RS-06-160

Clinton Power Station, Unit 1
Facility Operating License No. NPF-62
NRC Docket No. 50-461

Subject: Request for Emergency Amendment to Control Room Ventilation System
Technical Specification

Marked Up Technical Specifications Bases Page

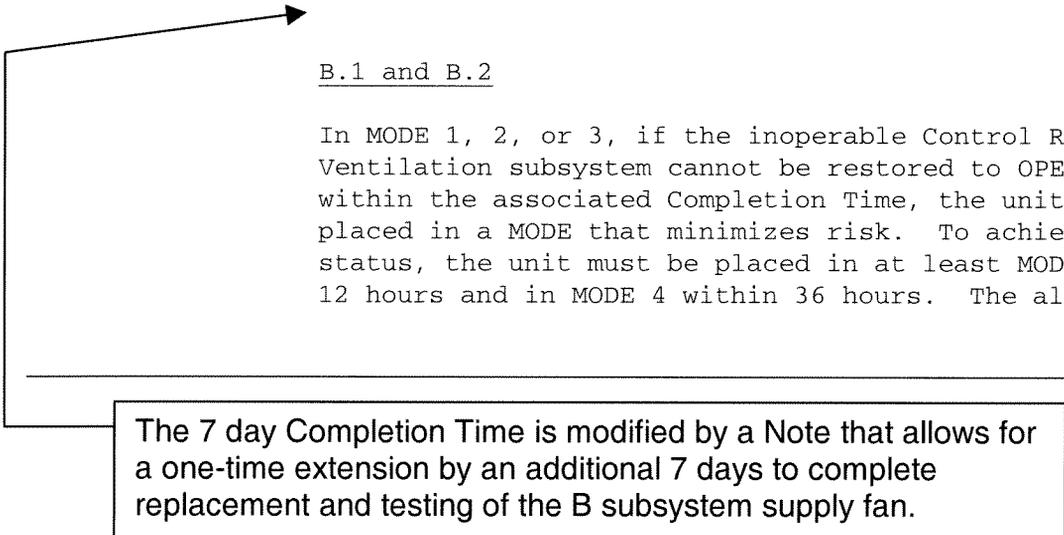
The 7 day Completion Time is modified by a Note that allows for a one-time extension by an additional 7 days to complete replacement and testing of the B subsystem supply fan.
